STAFF RECOMMENDATION
1824 5th Avenue North
June 19, 2019

Application: New Construction—Addition and Outbuildings; Setback Determination
District: Salemtn Neighborhood Conservation Zoning Overlay
Council District: 19
Base Zoning: R6-A
Map and Parcel Number: 08108027000
Applicant: Jeff Zeitlin, Developer
Project Lead: Paul Hoffman, paul.hoffman@nashville.gov

Description of Project: This application is for a rear addition and two carports at the rear of the lot. The applicant requests a setback determination for the addition's left side, from five feet (5') to three feet (3').

Figure 2: Different outbuildings were in place in 1957.

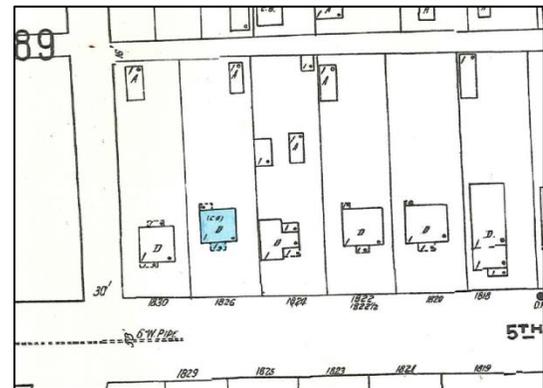
Demolition: An existing outbuilding is proposed to be removed. The exact date of construction is unknown, but it does not appear on the 1957 Sanborn map (Figure 2). The outbuilding does not contribute to the architectural or historical integrity of the district. As the addition is proposed for a second unit, the demolition plan does not include significant removal of the rear of the house. Staff finds that the proposed demolition of the outbuilding meets Section V.B.2 of the design guidelines for appropriate demolition, and does not meet Section V.B.1 for inappropriate demolition.

CARPORT

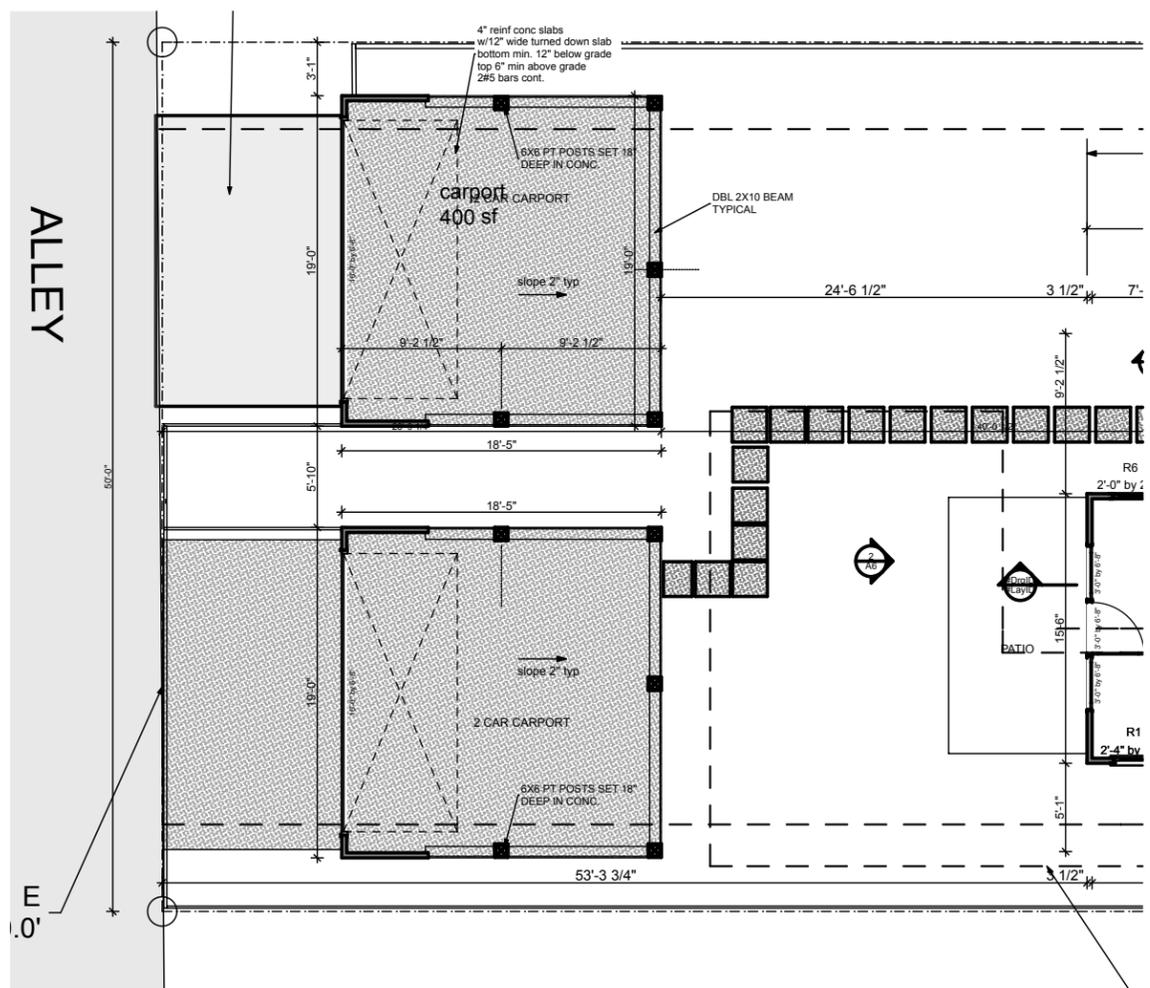
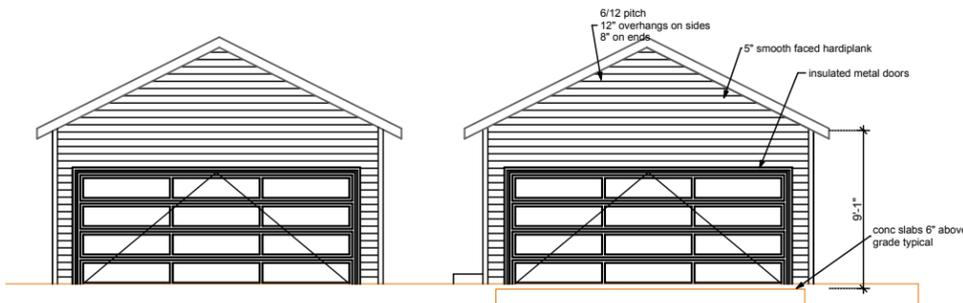
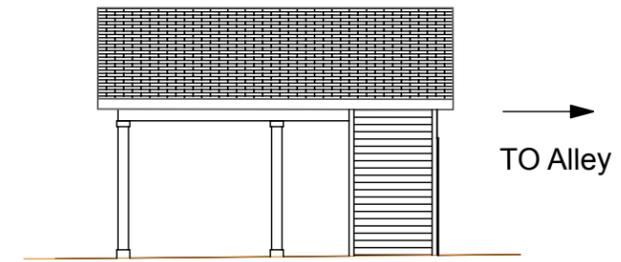
Section III.H for Outbuildings specifies that on lots less than 10,000 square feet, the footprint of a DADU or outbuilding shall not exceed seven hundred fifty square feet. The footprint of an outbuilding or outbuildings on a lot less than ten thousand square feet (10,000 sq. ft.) is limited to seven hundred and fifty square feet (750 sq. ft.) whether it is one structure or two. Staff therefore recommends that the total footprint of the outbuildings does not exceed seven hundred and fifty square feet (750 sq. ft.).

With the condition that the two outbuildings combined do not exceed seven hundred and fifty square feet (750 sq. ft.), staff finds that the location, height, scale, roof form, setbacks, and materials will meet Section III.H of the design guidelines for outbuildings.

1. The horizontal windows on the addition's left elevation be revised to a traditional window proportion;
2. The total footprint of the outbuildings is reduced not to exceed seven hundred and fifty square feet (750 sq. ft.);
3. Staff shall review and approve all materials prior to purchase and installation.
